Subject: UniStar Nuclear Energy, NRC Docket No. 52-016
Response to Request for Additional Information for the
Calvert Cliffs Nuclear Power Plant, Unit 3,
RAI No. 144, Other Seismic Category I Structures, and
RAI No. 145, Foundations

Response to NRC Request for Additional Information

**RAI 144, Other Seismic Category I Structures,
Questions 03.08.04-01 through 03.08.04-14,**

Calvert Cliffs Nuclear Power Plant, Unit 3

Figure 3.8-5 {Isometric View of the Basemat Finite Element Mesh (half model) for the CWS Makeup Water Intake Structure, Forebay, UHS Makeup Water Intake Structure, and UHS Electrical Building}

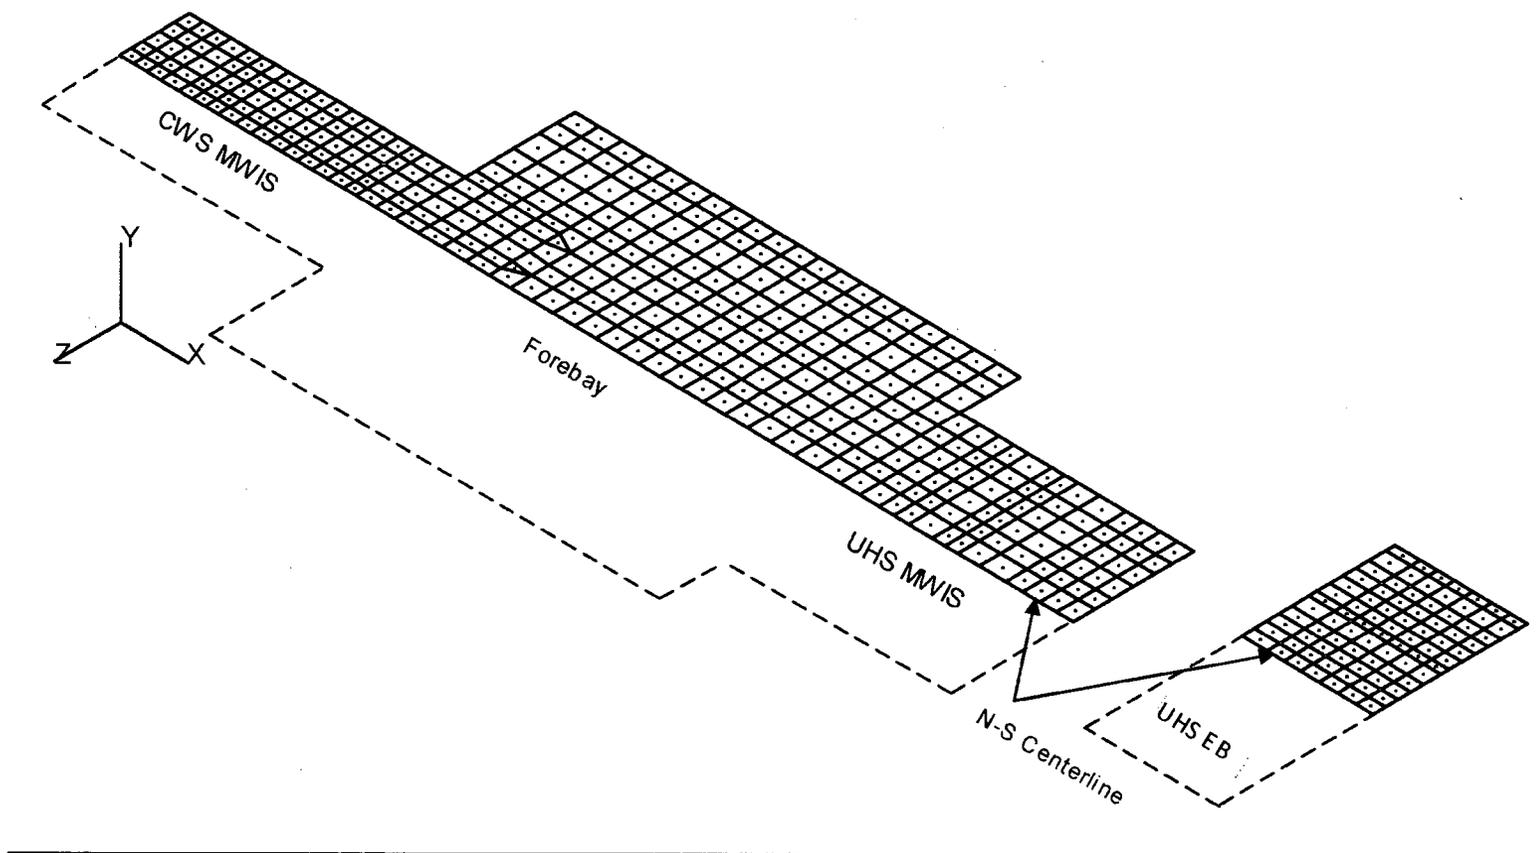
- c. Explain why the concrete shear keys below the basemat are not included in the FEM and why the sloped concrete walls on the North-West side of the UHS Makeup Water Intake Structure, shown on Figure 3E.4-2, are not also sloped in the FEM on Figure 3.8-5.

- c) Shear keys are not utilized in the current configuration of the structure and hence are not modeled in the FEM. The sloped wall in the FEM is the North wall of UHS MWIS. The wall is sloped at an angle of 10 degrees to the vertical. However, for simplification of the finite element model, the wall is modeled as vertical and in line with center line of Forebay wall. As described in updated CCNPP Unit 3 FSAR Section 3.7.2.3.2¹, this simplification has an insignificant effect on the global mass and stiffness distribution, and is conservative for the local response of structural panels. This simplification has little effect on the design of the sloped wall and critical sections described in revised CCNPP Unit 3 FSAR Appendix 3E.4. Localized impact on the design of operating deck slab will be addressed during the detailed design engineering.

Figure 3.8-6 {Conceptual Configuration of Waterproofing Membrane}

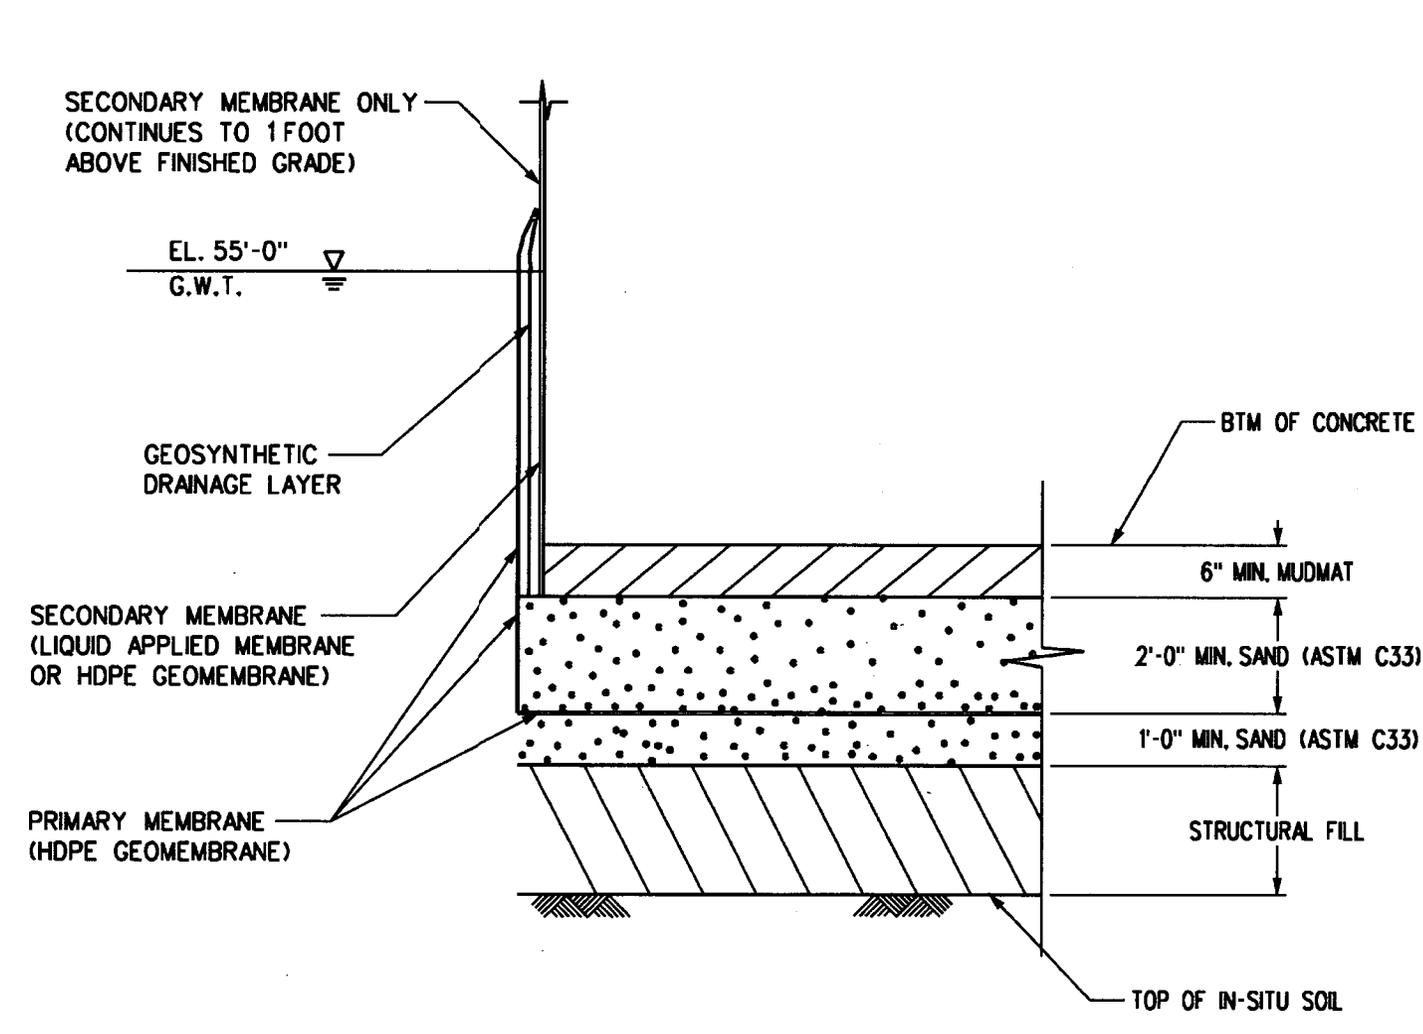
1. Describe in detail, the waterproofing system that is used for all below grade concrete structures including the buried electrical duct banks and buried piping. The description should include the type of waterproofing membrane, material composition, thickness, type of joints for the membrane, and installation process. For the installation process, explain how it is assured that the waterproofing membrane will not be damaged in any manner.

For the protection of the concrete foundations, a sheet of textured HDPE sandwiched within two sand layers will be installed beneath the mudmat of the structure and will be contiguous with the primary HDPE geomembrane on the buried walls. A system to monitor and pump out any water collected within the resulting geomembrane envelope will also be installed. Additional discussion on the monitoring system is provided in response to Question 03.08.04-12. The waterproofing system concept is shown in revised CCNPP Unit 3 FSAR Figure 3.8-6 provided in Enclosure 3.

As discussed in the response to RAI 144 Question 03.08.04-4, waterproofing membrane is utilized to protect foundation basemats subject to low-pH groundwater. The waterproofing membrane is envisioned to be placed between two layers of compacted sand (complying with ASTM C33), as illustrated in revised CCNPP Unit 3 FSAR Figure 3.8-6.

Revised CCNPP Unit 3 FSAR Figure 3.8-6 shows the conceptual configuration of waterproofing membrane along with various interface layers beneath the basemat of the Nuclear Island Common Basemat Structures. Potential sliding interfaces below the NI structure foundation basemat and the associated friction coefficients are as follows:
